780 BLANSHARD - REHABILITATION + ADDITION

HAV00034 CONCURRENT WITH REZ00825

Bubbled areas indicate revisions compared to the previously submitted plans

DATE	REV	ISSUE DESCRIPTION
2022-02-24	1	REZONING PRE-APPLICATION
2022-06-01	2	OPEN HOUSE PROGRESS SET
2022-06-21	3	REZONING APPLICATION
2023-03-23	4	HAP & REZONING RESUBMISSION

A036

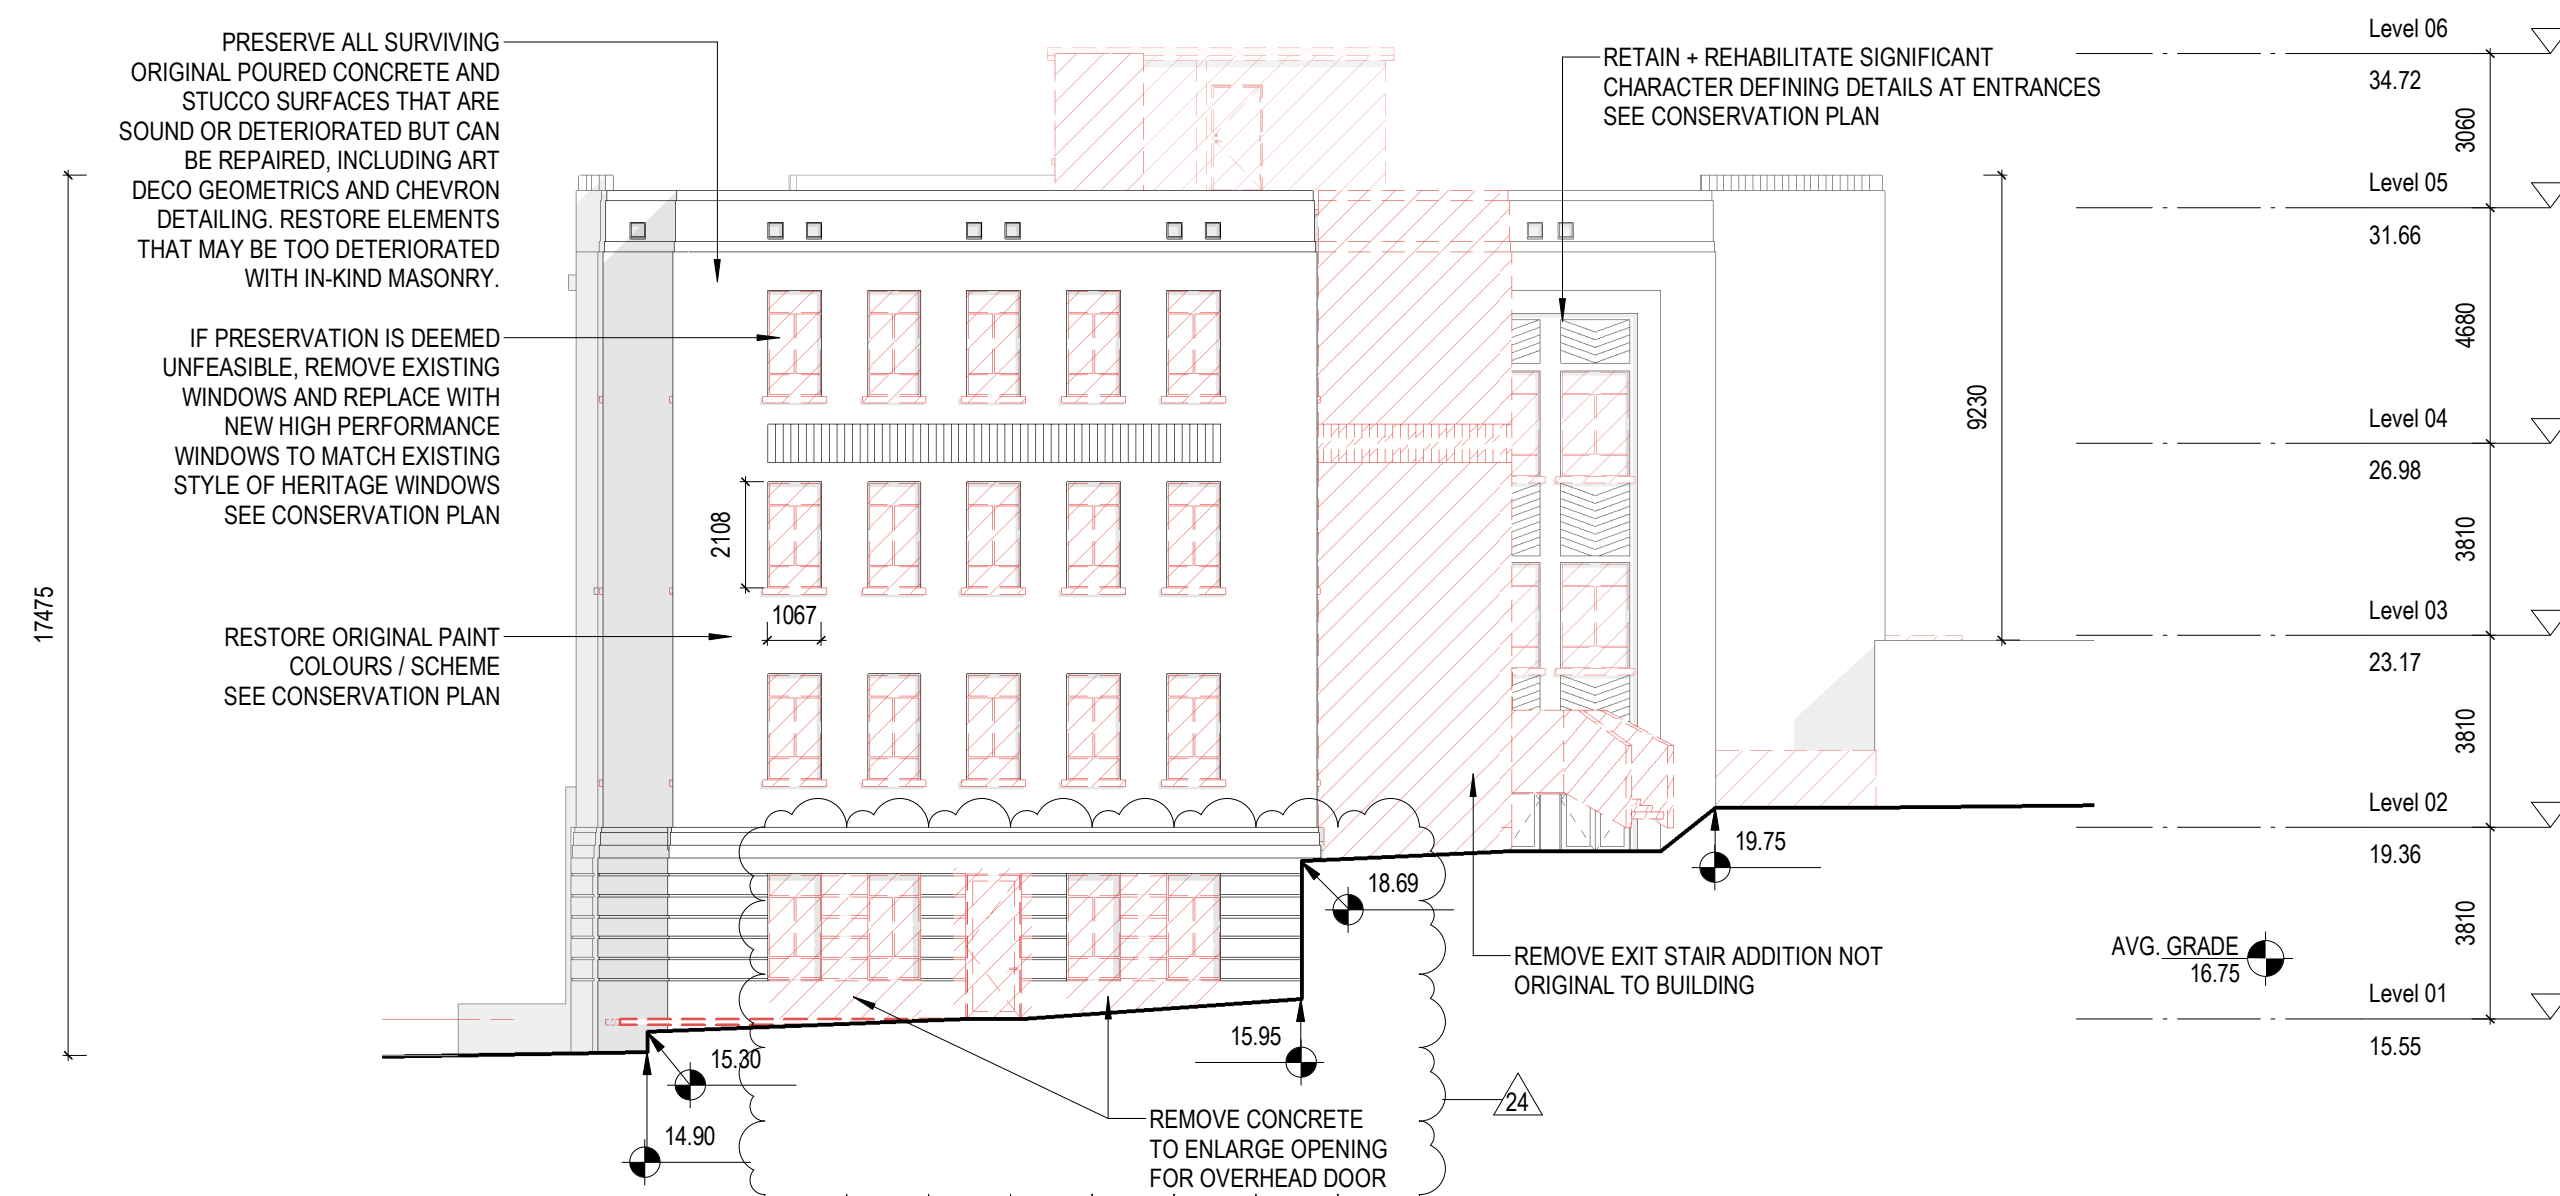
24 Extent of concrete demolition modified to reflect planning updates from interior design development and as a result of missing changes from ARS Comment #22.

SITE PLAN PROPOSED

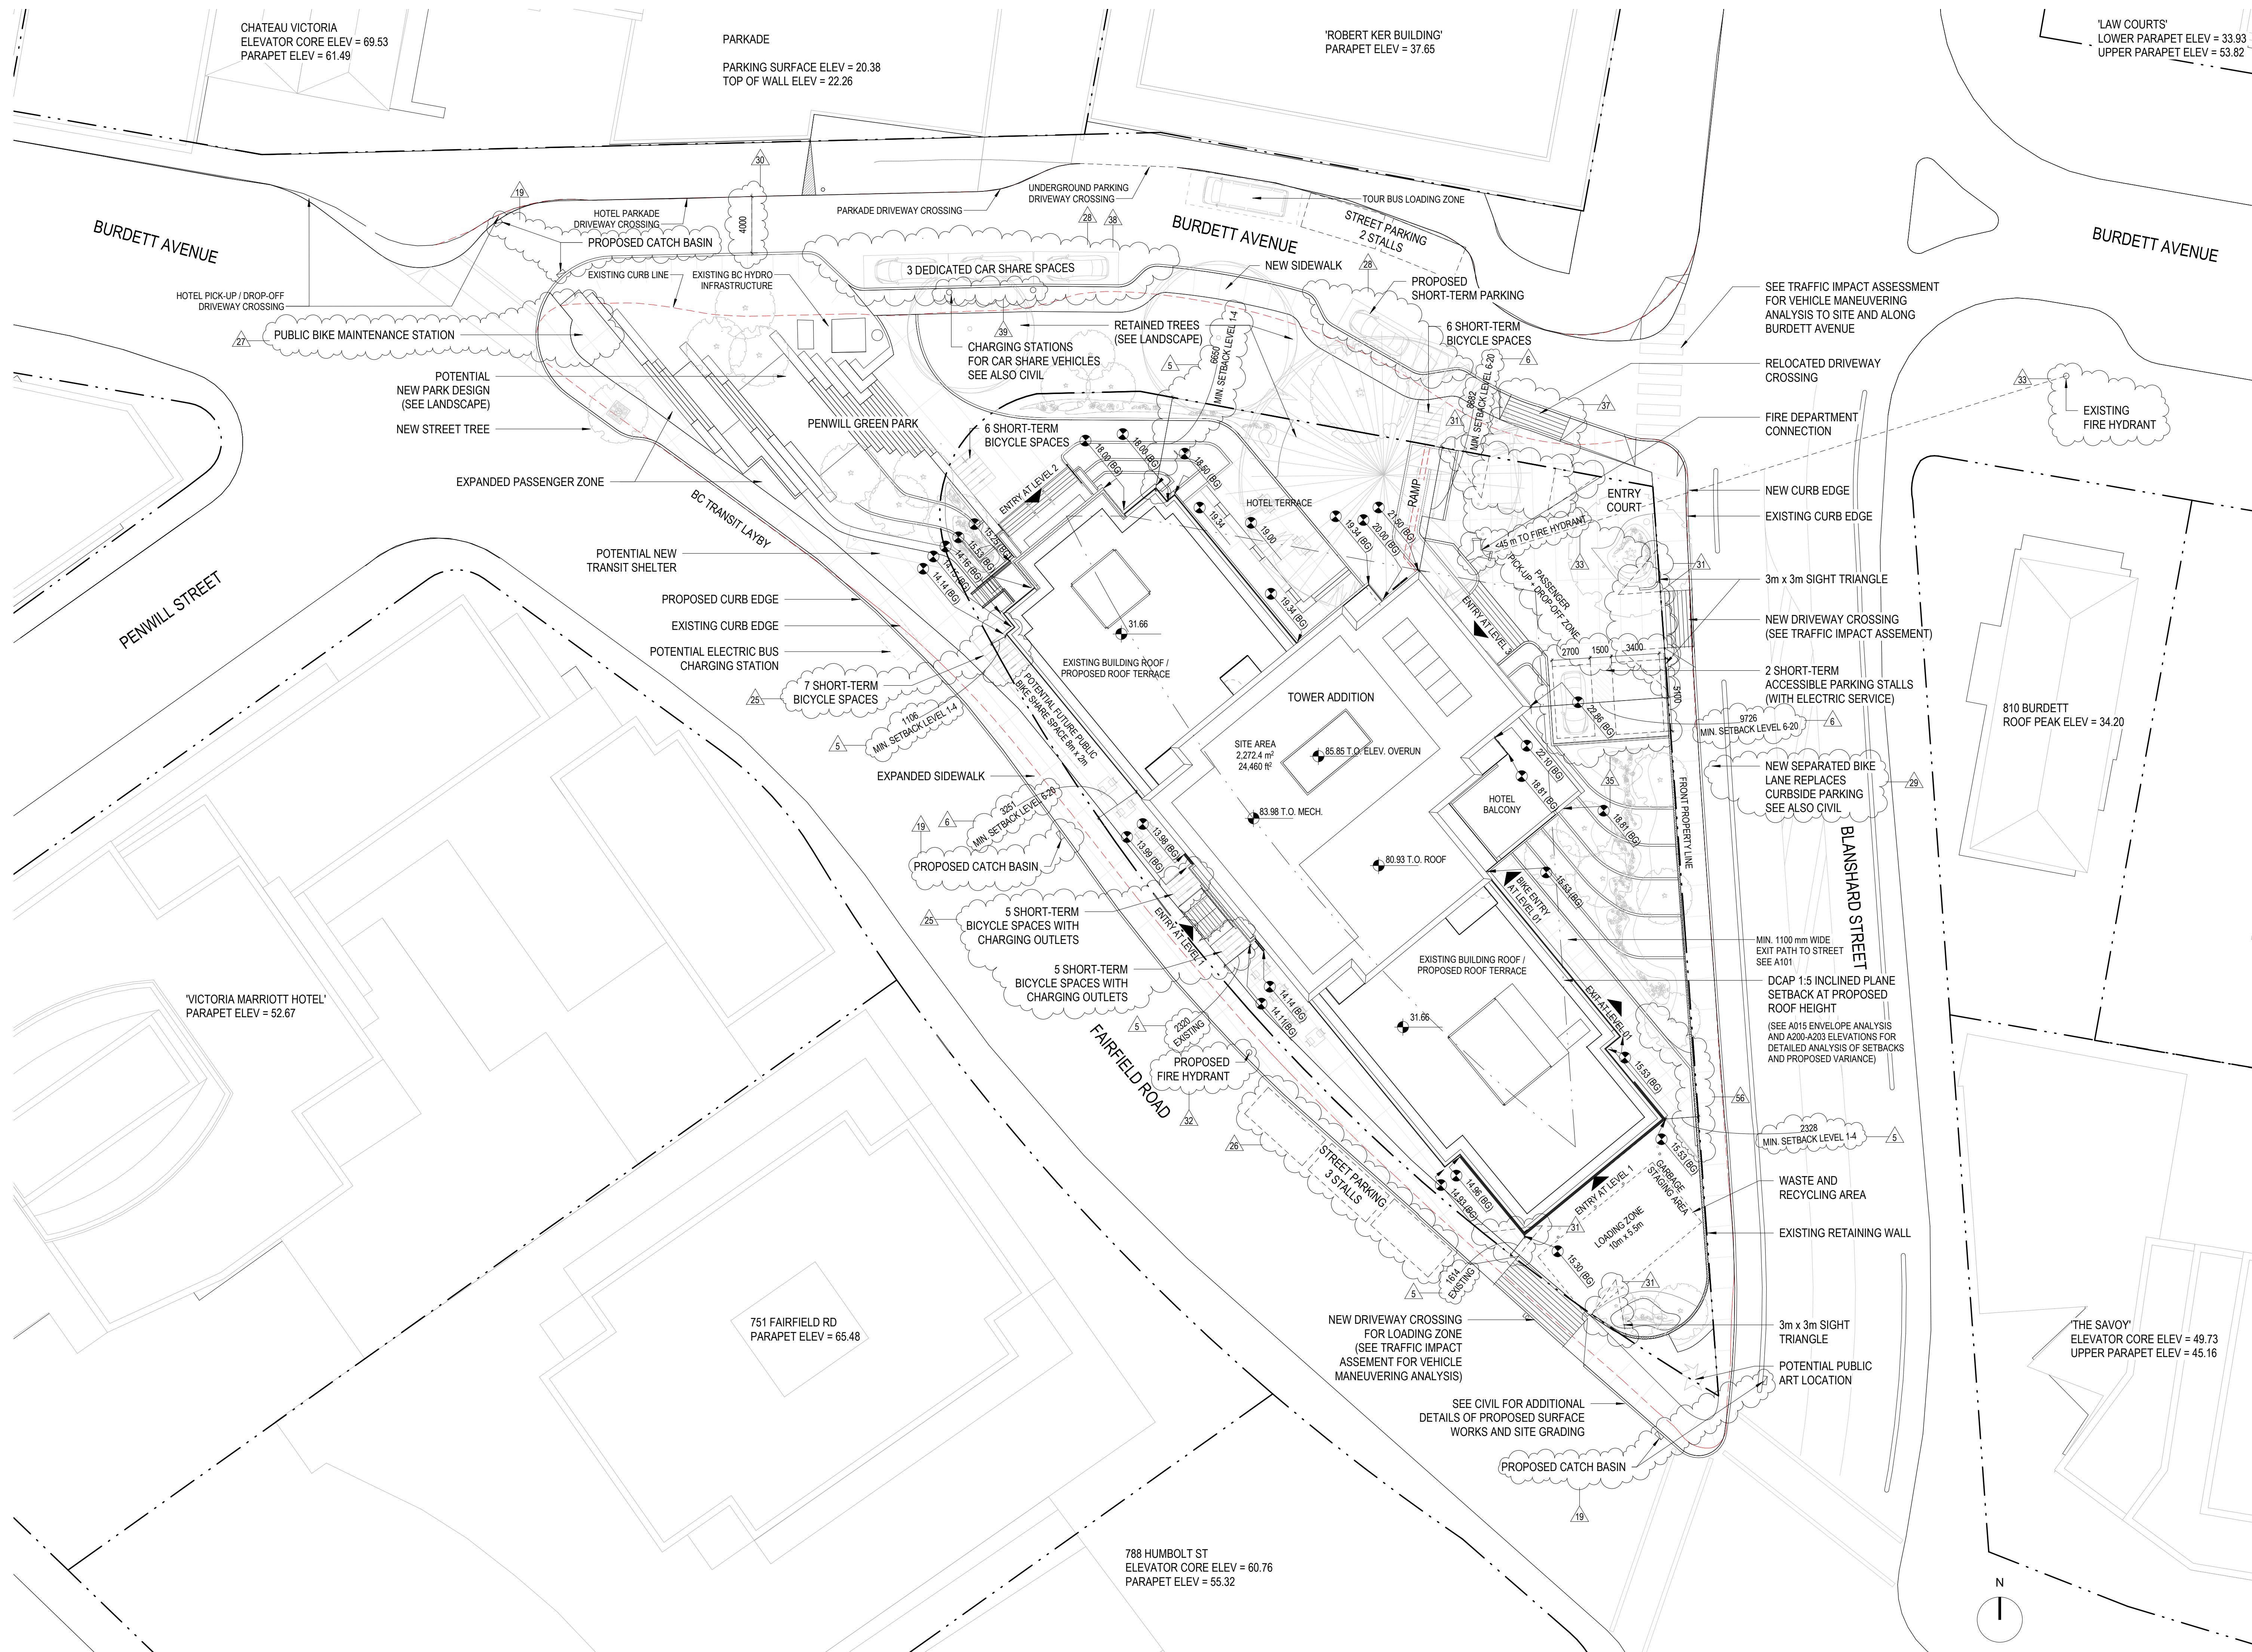
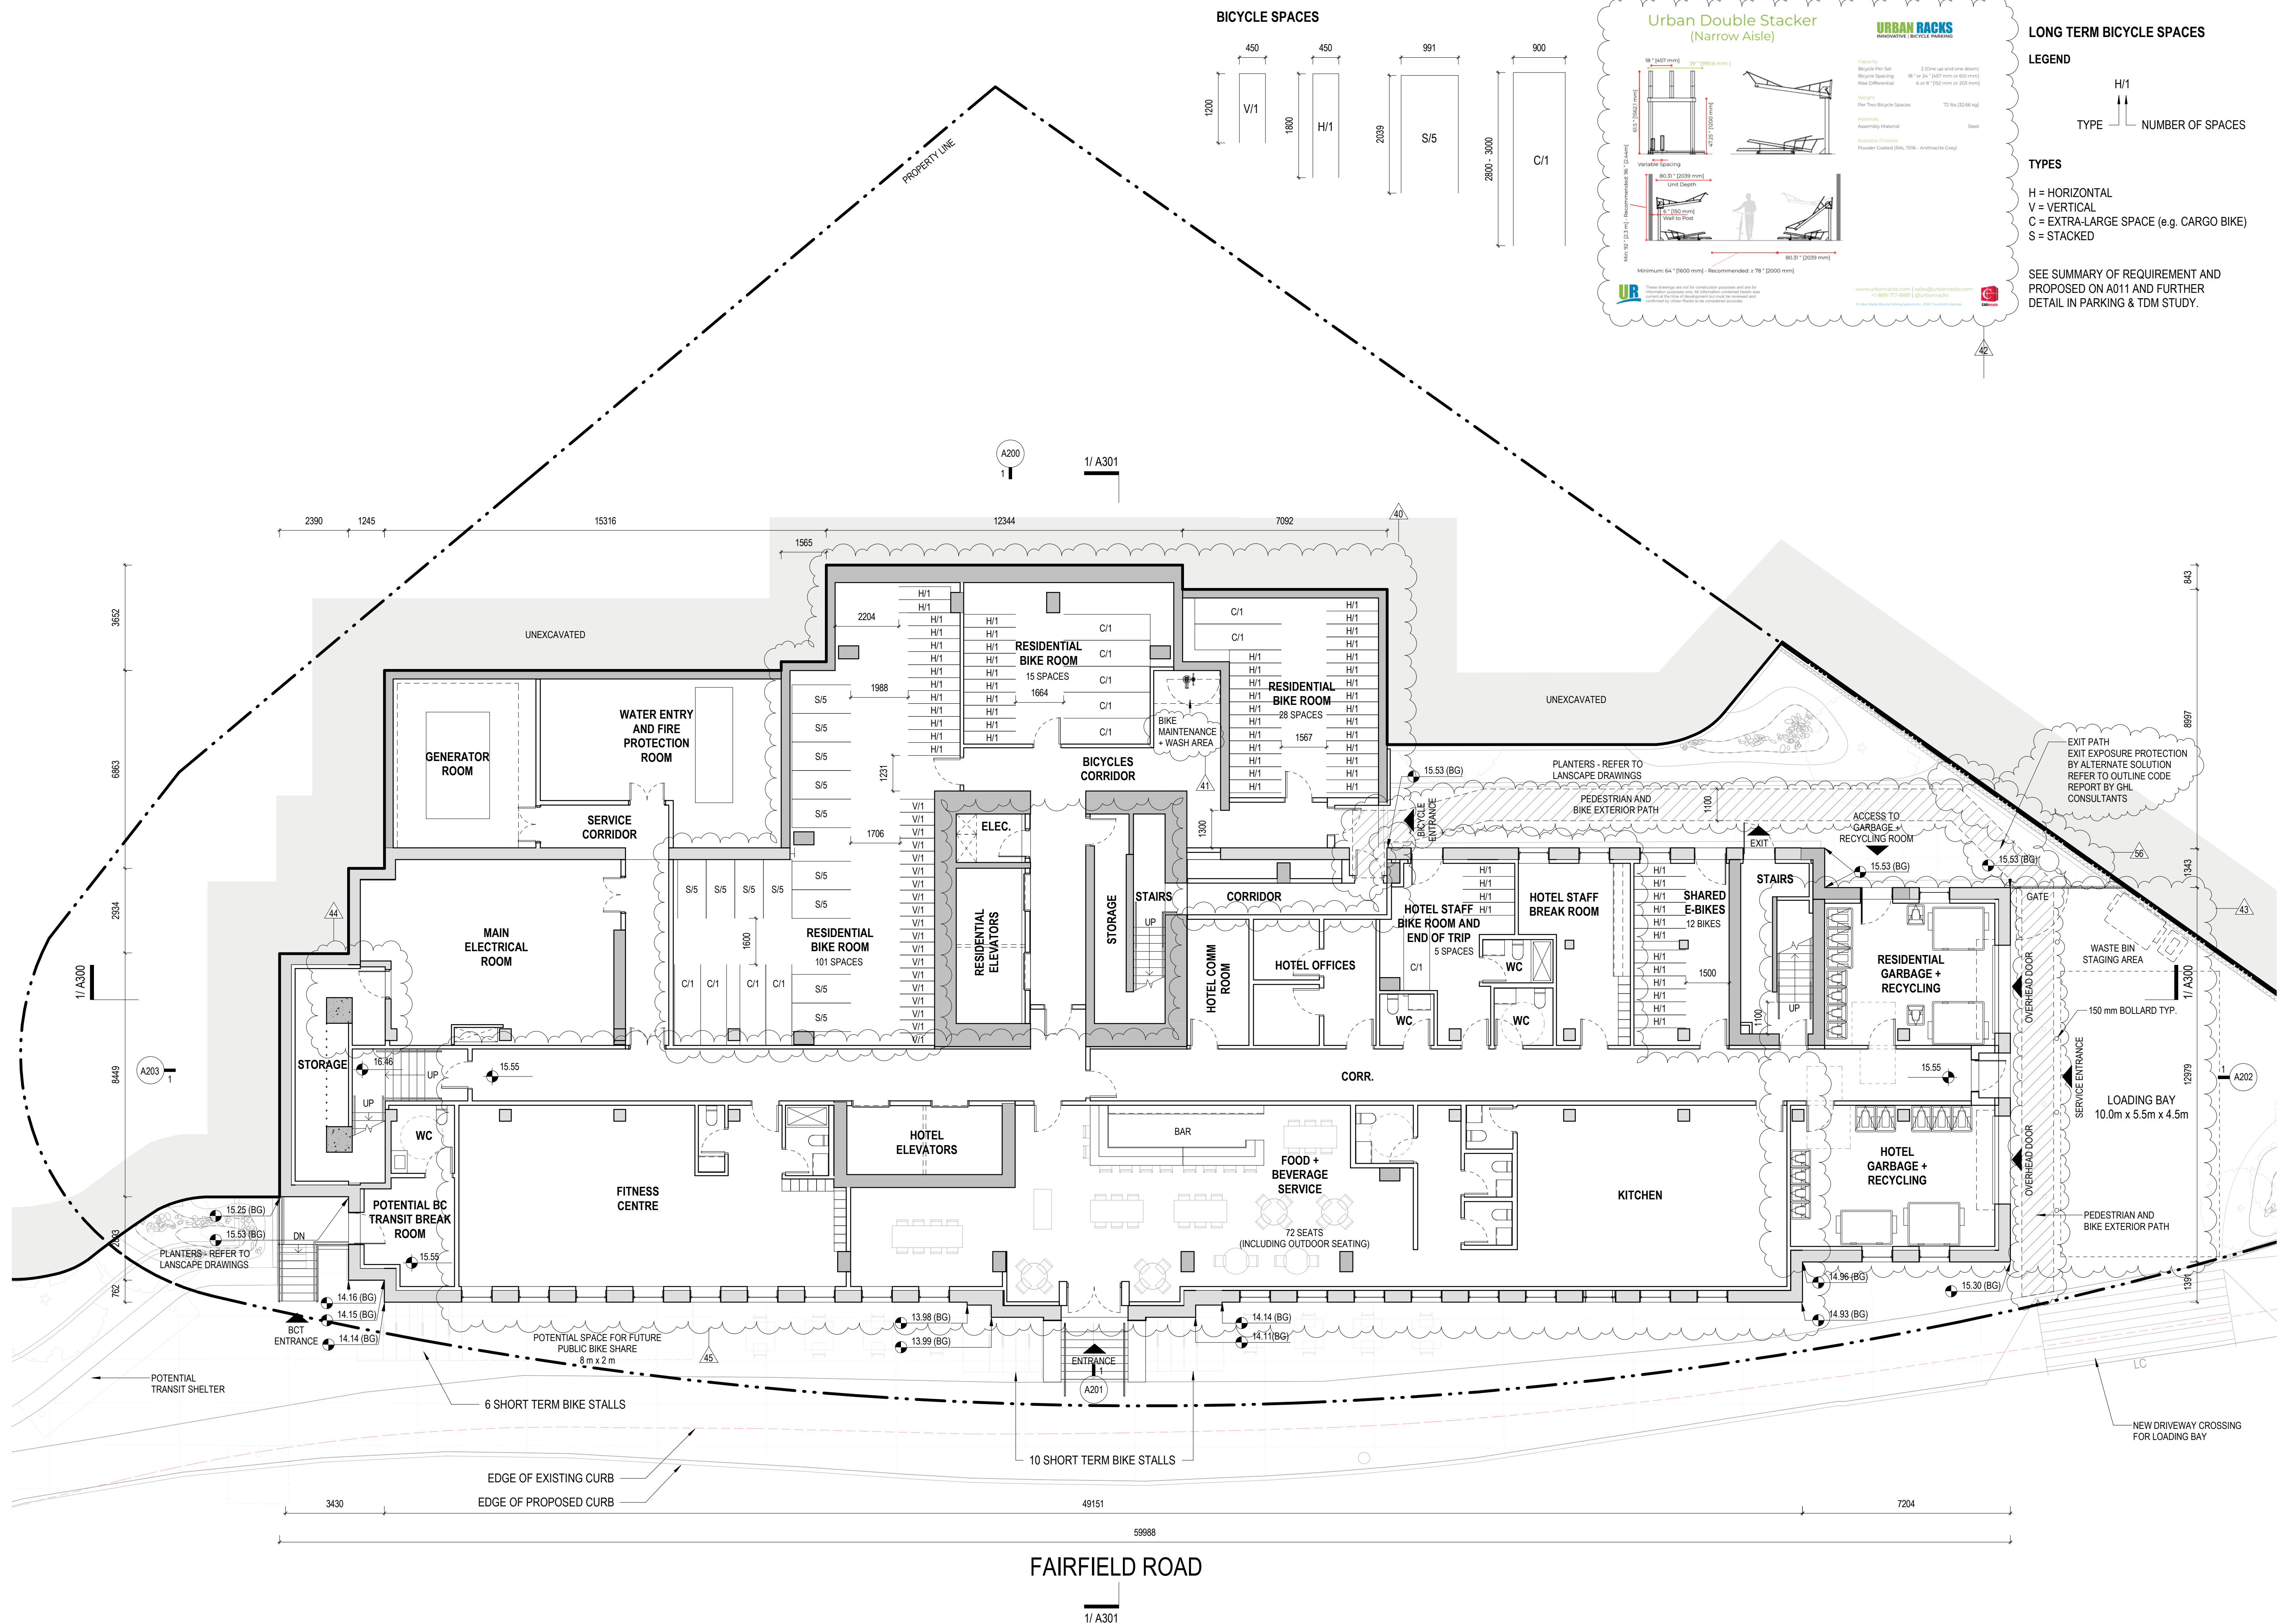
- 19 Added for completeness of HAP application documents.
- 20 In response to ARS Comments #56 and #69), short-term bike parking with charging access and for over-sized bikes added to deck see also Landscape and Parking TDM Study

- 21 In response to ARS Comment #52, label provided for curbside parking on Fairfield Road showing reduction from 5 stalls to 3 stalls allow for driveway crossing to loading area.

- 22 Public bike maintenance station included in park design in response to ARS Comment #65.
- 23 Curb configuration and stall sizes updated per ARS Comment #66.

- 24 New bike lane shown per ARS Comment #54. Replacement of curbside parking noted per ARS Comment #52.
- 25 Minimum with provided per ARS Comment #50.

- 26 Sight triangles added to address ARS Comment #64 and #63.
- 27 Proposed hand truck noted on this plan and relocated to City ROW ARS Comment #77.
- 28 Closest fire hydrant shown and distance from FDC noted to address ARS Comment #122.

- 29 In response to ARS Comment #34 (plan check #50) Parking reconfigured to match accessible stall requirements. See also Traffic Impact Assessment and Parking & TDM Study from WATT Consulting Group.
